# EnvironmentalBoard

New version of enviromenal board with MCP25625 CAN controller with integrated Tranciver

IRNAS		irnas.eu
Title: EnvironmentalBoard.PrjPcb		
Page Contents		PAGE1-CONTETNS.SchDoc
Size:	DWG NO	Revision: V0.3
Date: *	Sheet * of *

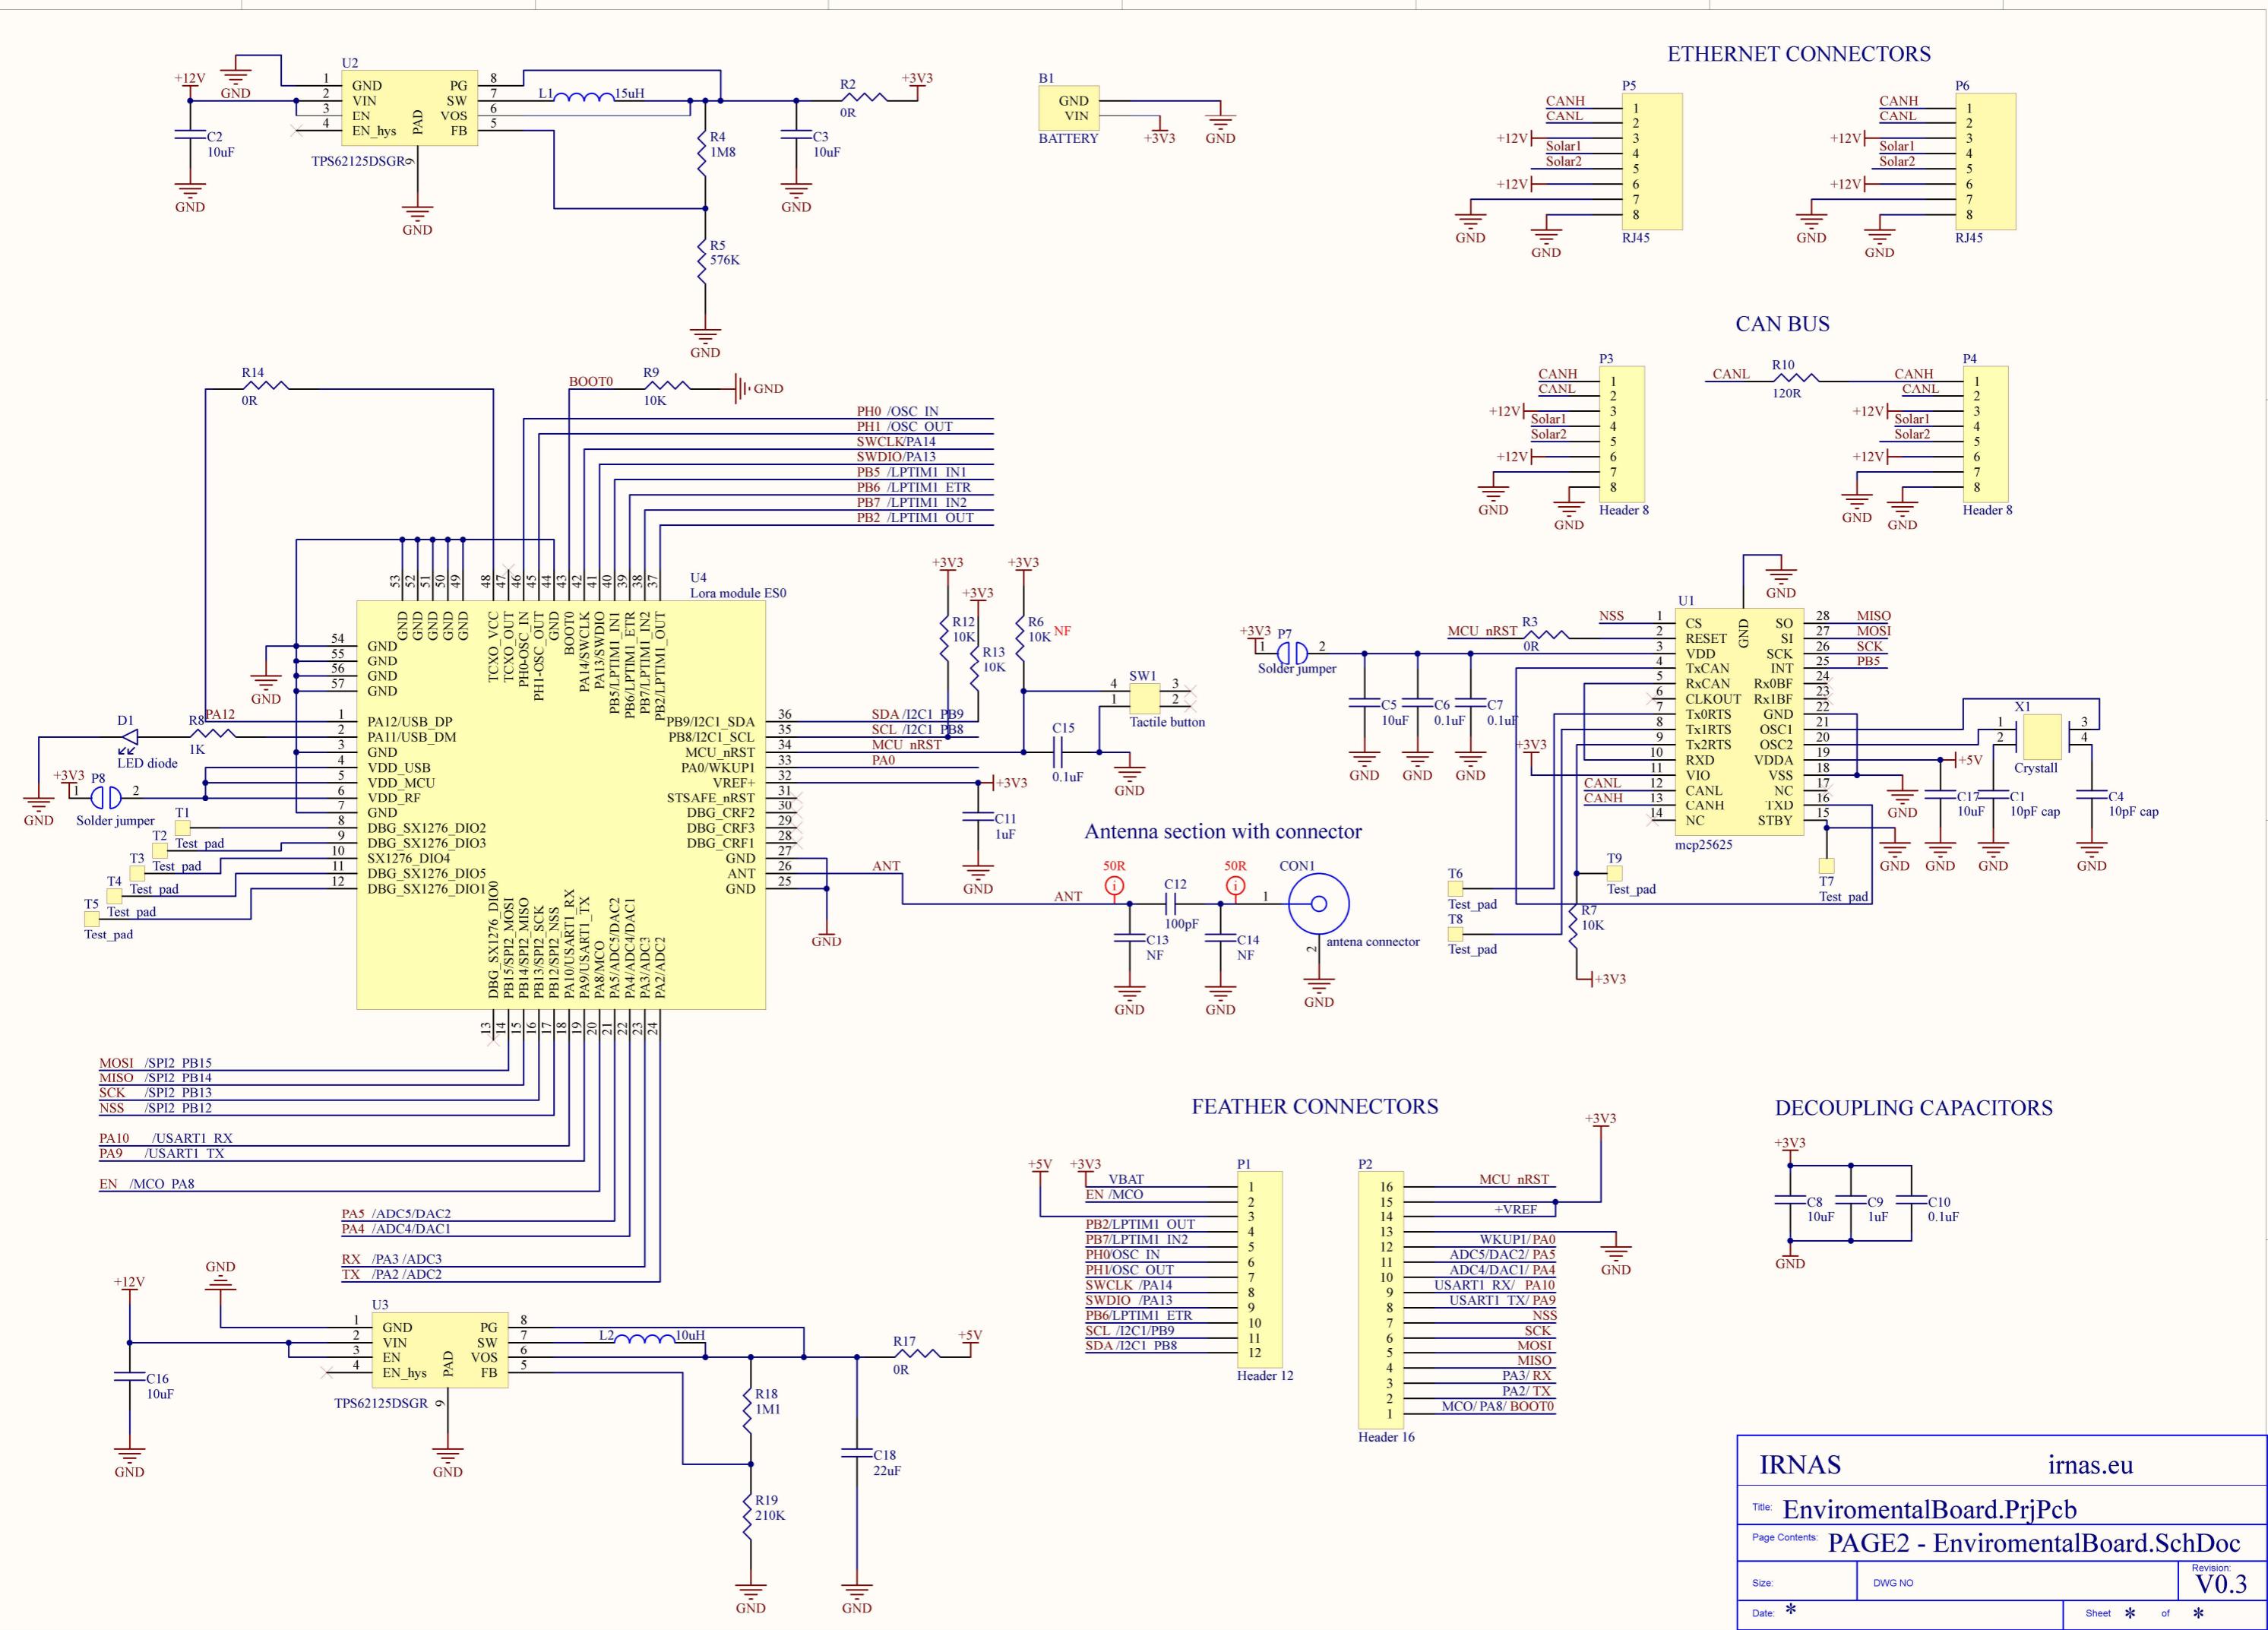
1. Crystall X1 wrong wiring
2. Crystall X1 wrong footprint
3. Crystall X1 needs repositioning closer to MCP25625
4. Ethernet connector PIN 1 not marked
